## **ADDENDUM NO. 1**

**ELEVATOR ADDITION FOR DREWRY MASON ES, HENRY COUNTY PUBLIC SCHOOLS  
RRMM ARCHITECTS  
ROANOKE, VIRGINIA  
COMM. NO. 21195-16**

**8-11-25**

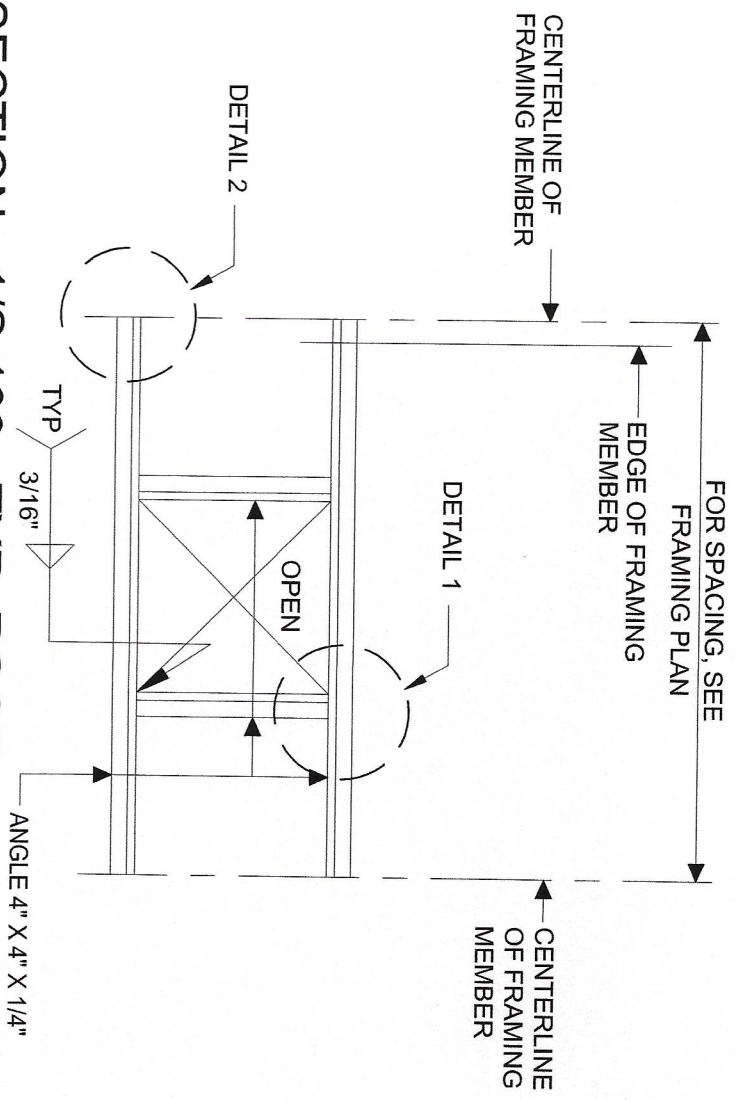
1. On E-101, Plan Note #5 mentions that "TKE will provide the shunt trip disconnect for cab lighting." It also says that we are to provide a 30A, 240V, 3-Pole, N3R, fused disconnect, but doesn't specify what it is for. I would assume the disconnect we are providing is for the cab lighting, and TKE is providing the elevator disconnect w/ shunt trip and auxiliary contacts. Plan Note #2 on E-102 mentions that TKE will provide all shunt trip devices and means of disconnection. Please advise.
2. What type of fire alarm system does this school currently have? Does Henry County Public Schools have a preferred fire alarm vendor?
3. On E-102, Plan Note #8 mentions the twist lock receptacle for the sump pump being in a N4X box. Does this need to be N4X? The other devices in the elevator pit call for weather proof or N3R enclosures.

Comment #1 - LPA Response: Provide as noted to support the cab lighting.  
Comment #2 - LPA Response: existing Fire Alarm - Siemens  
Comment #3 - LPA Response: provide as noted on the contract documents.
